United States Department of the Interior

February 23, 2024

Subject: U.S. Department of the Interior Comments – *Draft American River Common Features, 2016 Flood Risk Management Project, Sacramento, California, Supplemental Environmental Impact Statement/ Subsequent Environmental Impact Report XIV.*

Figure 17 - ARCF lithostratigraphic riverbank cross section 1 (Watt Avenue)

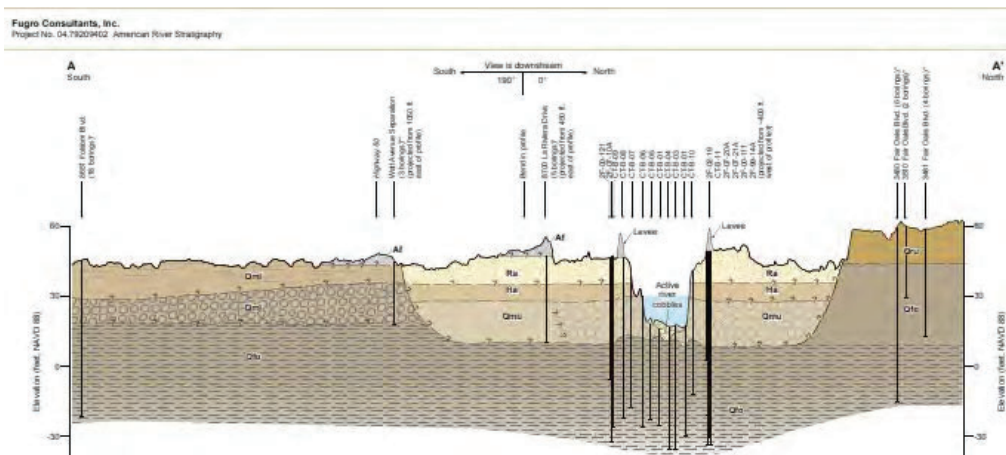
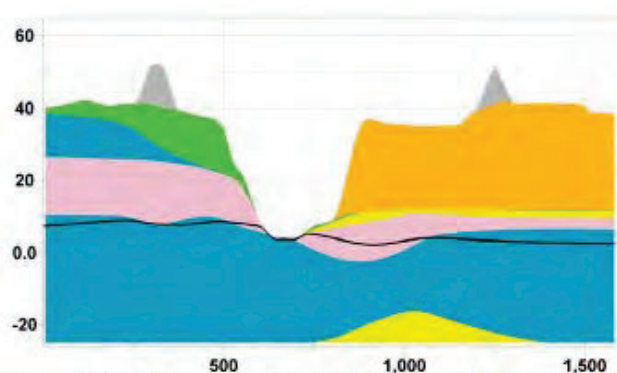
- 49 e. It's the reviewer's understanding that only a regional, non-detailed, lithostratigraphic based three-dimensional geologic conceptualization of the subsurface exists for the ARCF project. In general, detailed cross sections of river-bank geology were not presented with the exception of one cross section across Watt Avenue (Fugro 2012) (top image next page).

Figure 1

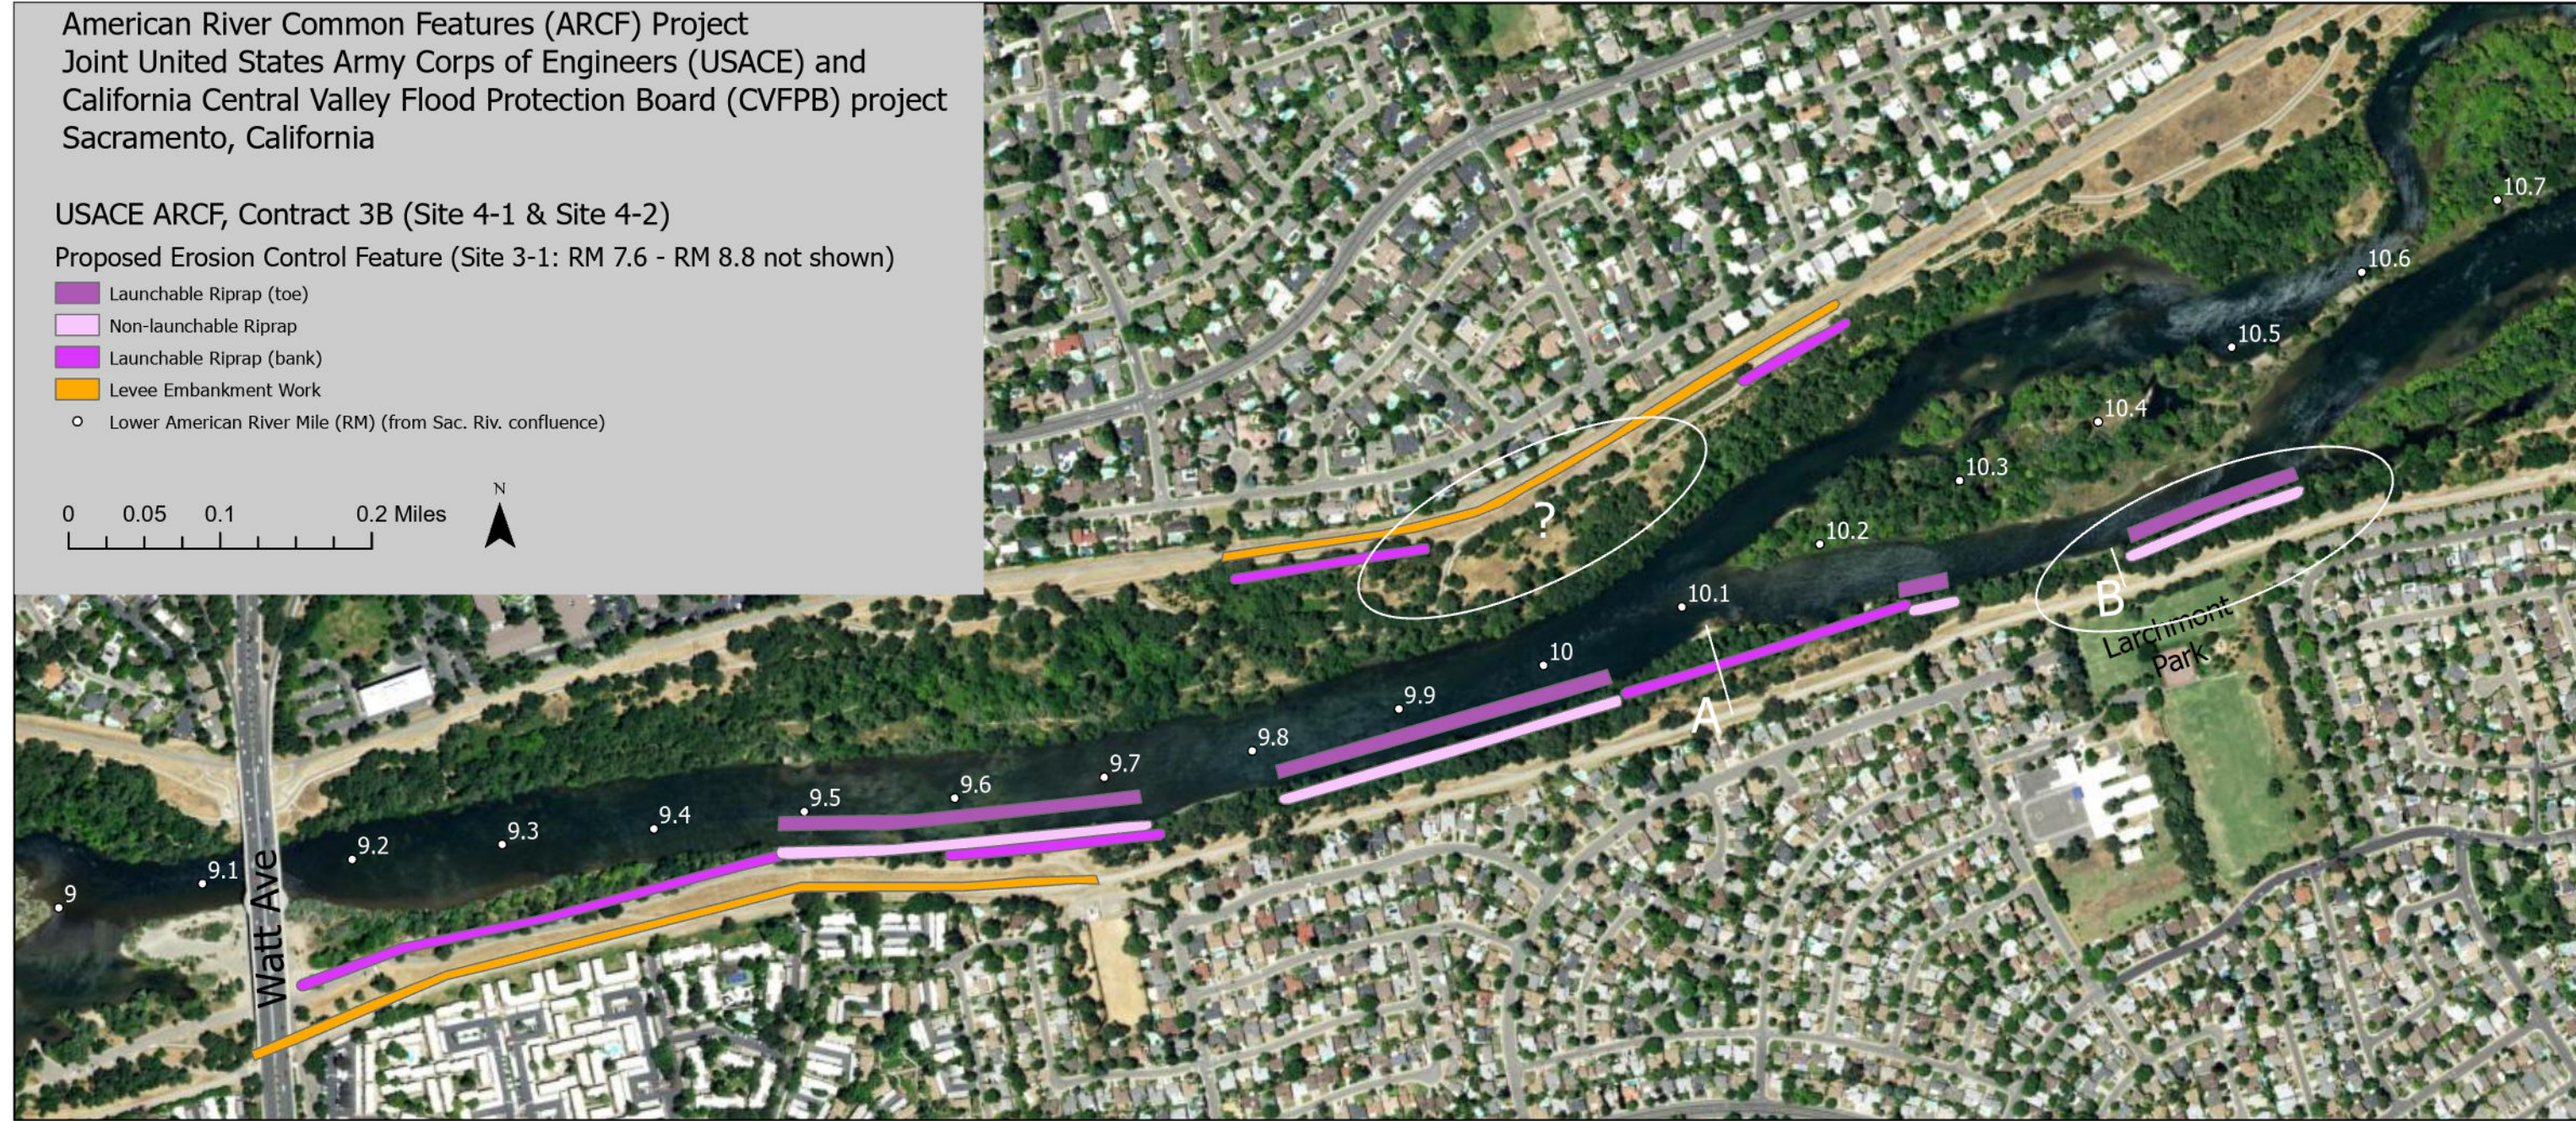
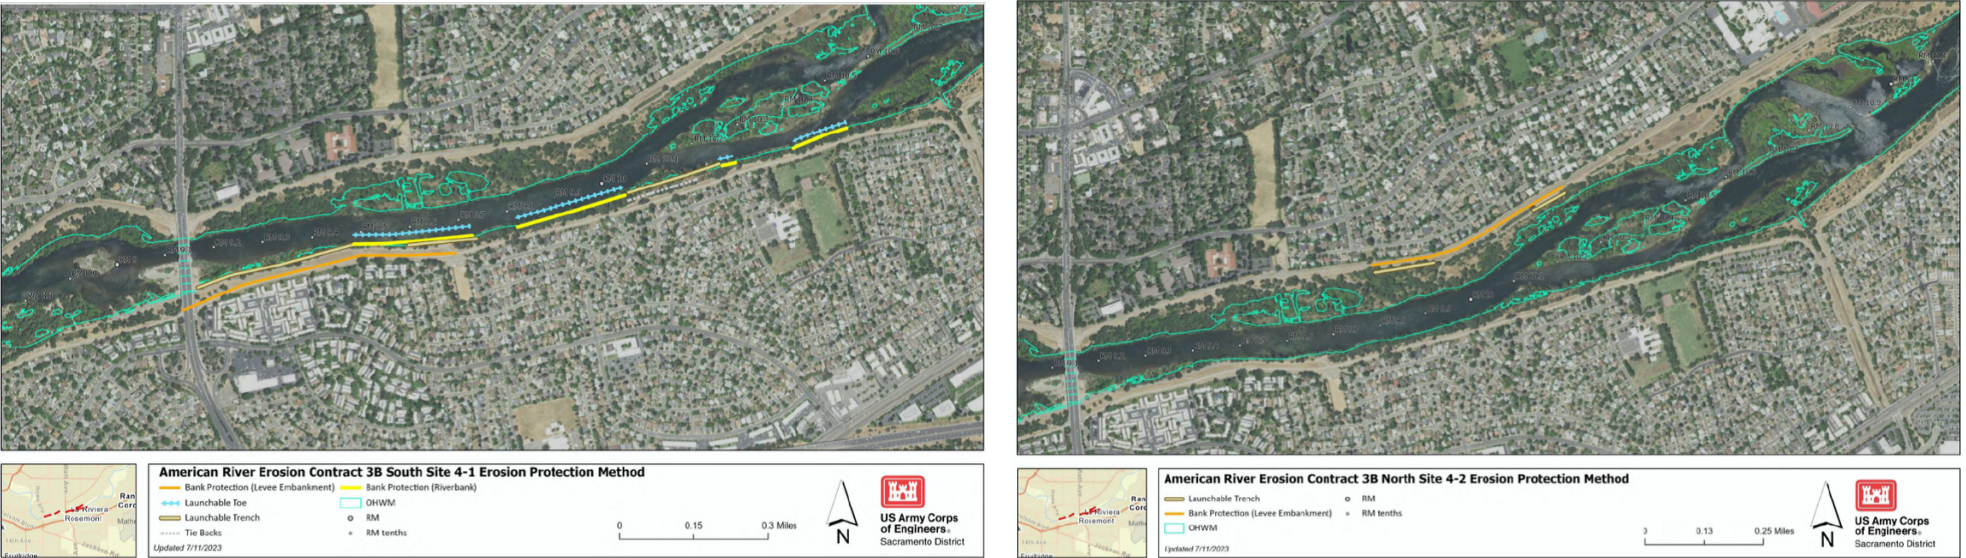
Zooming in beyond the scale of detail that was presented in the FEIR/FEIS (shown as the upper image in Figure 2 – zoomed out to approximately twelve square miles of Sacramento), it’s apparent that some Erosion Control Protection methods are planned in locations with very slow to stagnant water, and others are not planned in locations with much faster velocity. These two locations are indicated by two ellipses, one with a “?” and one with a “B”. What is the rationale behind this decision?

This figure combines Site 4-1 and Site 4-2 into one view with more resolution than provided in the SEIR/SEIS. Note transects "A" and "B" and ellipses marked by "?" and "B".

Figure 2

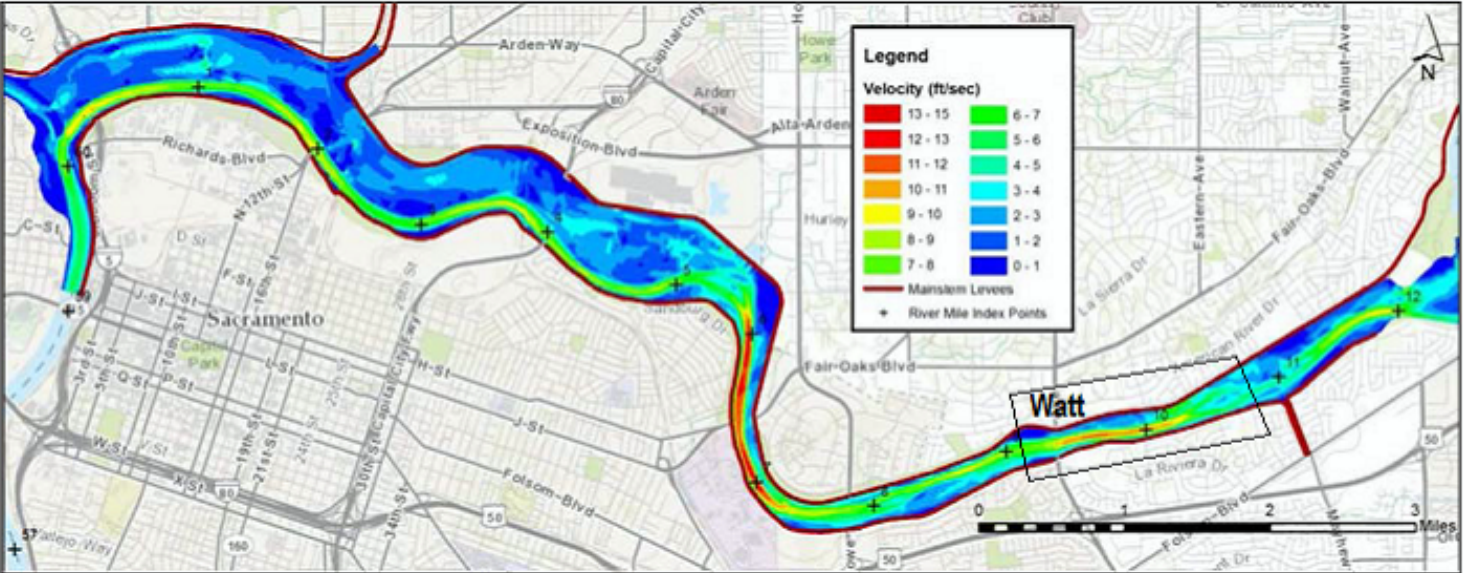
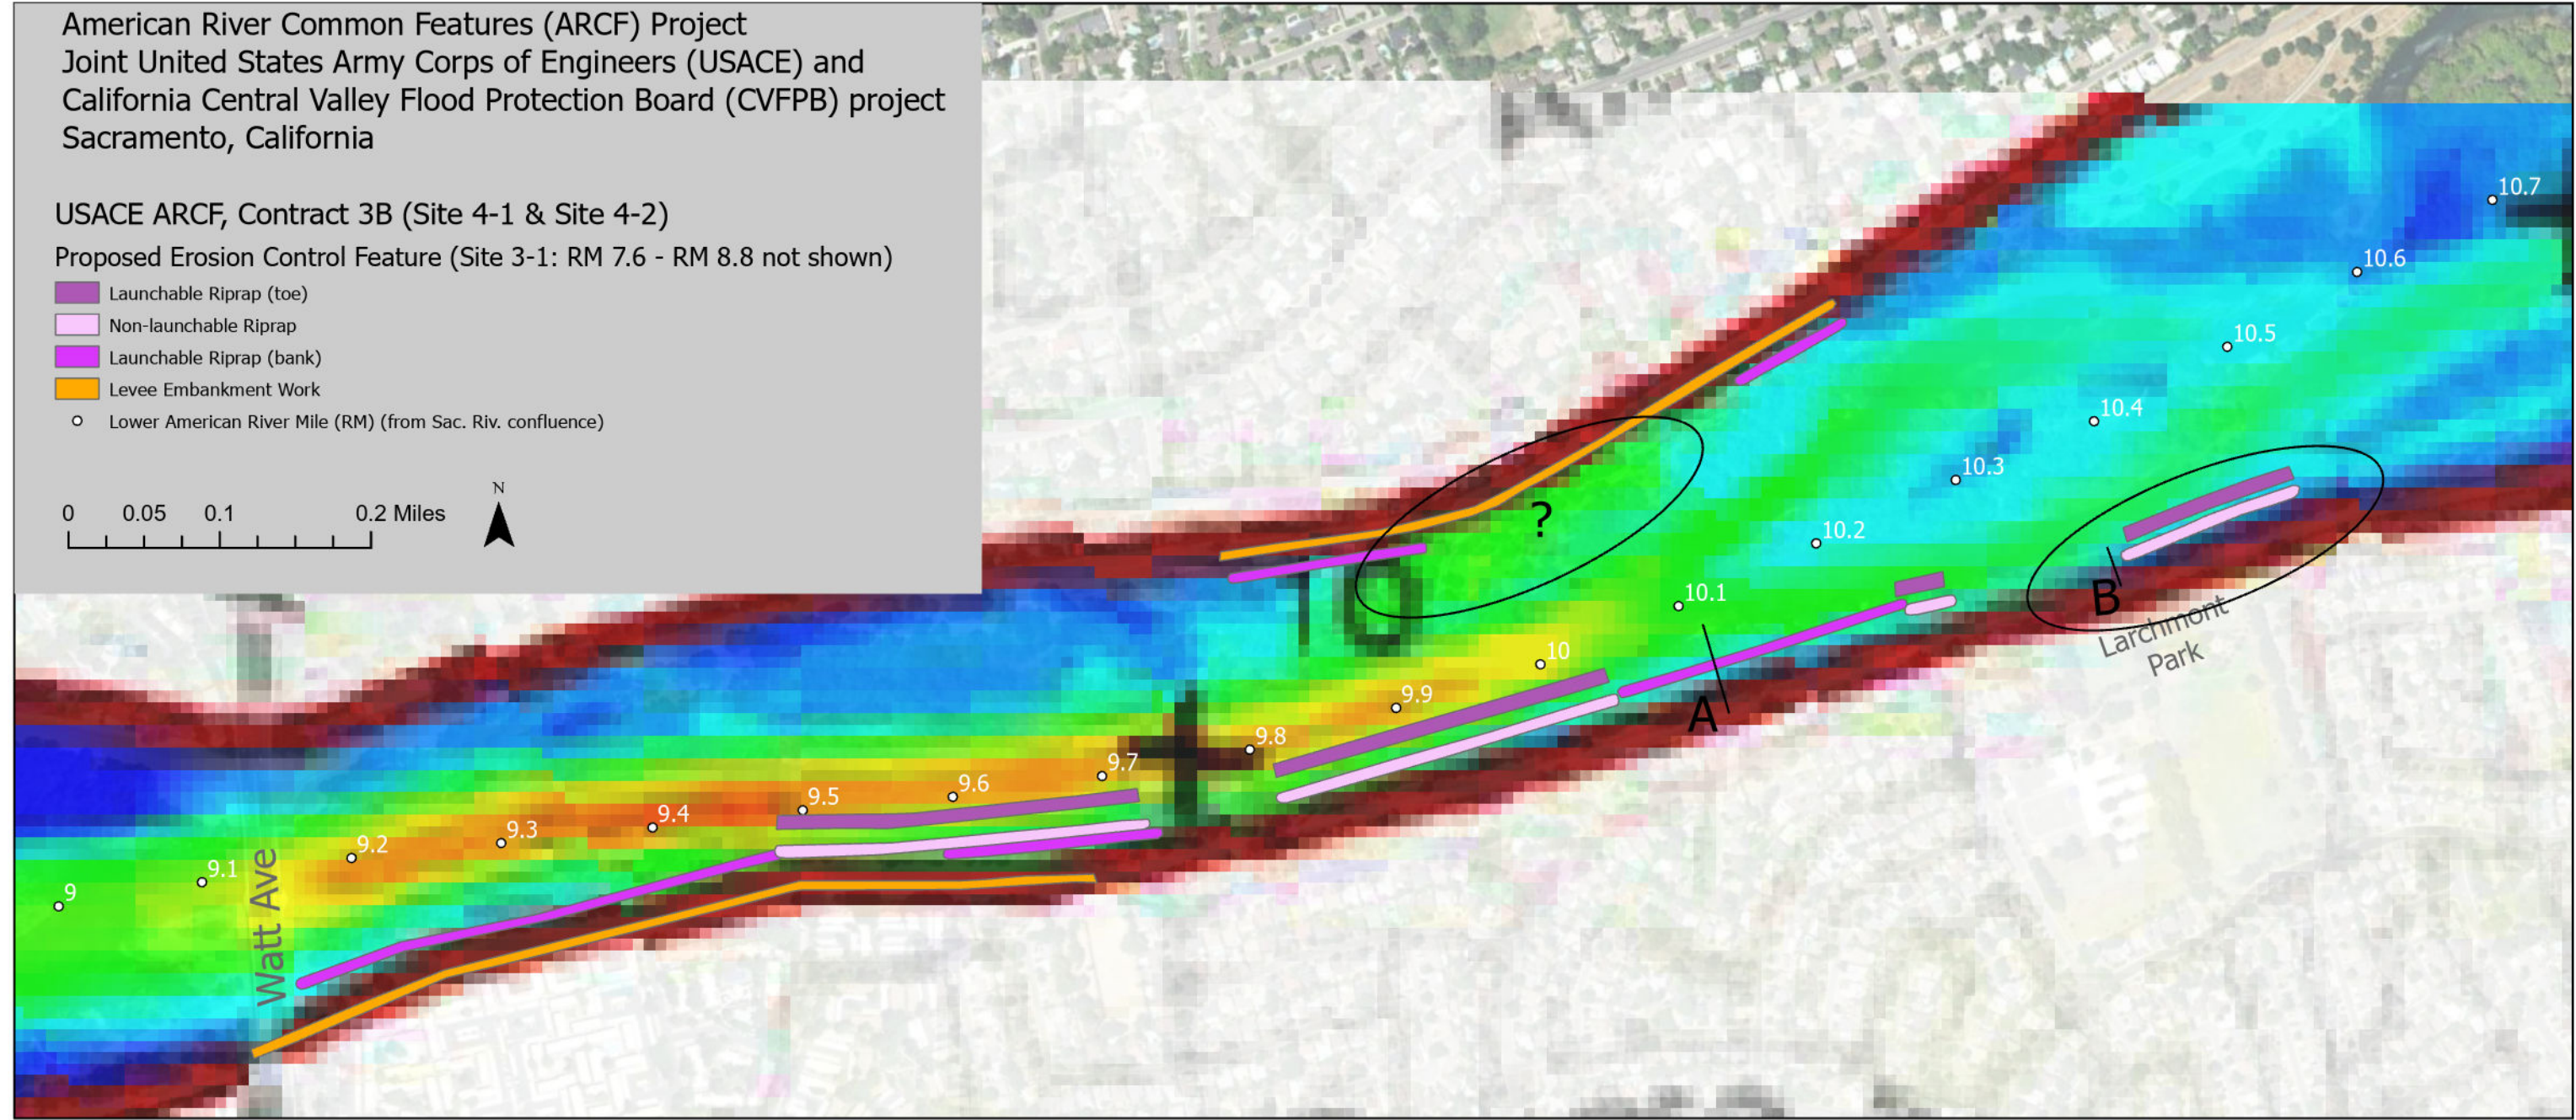
This figure shows the original resolution of the depth-averaged 160 kcfs model velocity output shown in the FEIR/FEIS (at right) and how it's poorly resolved when zoomed into some of the Project footprint (below). Note erosion control features are planned in low-velocity "B" area and none are planned in the higher velocity "?" area where the channel thins.
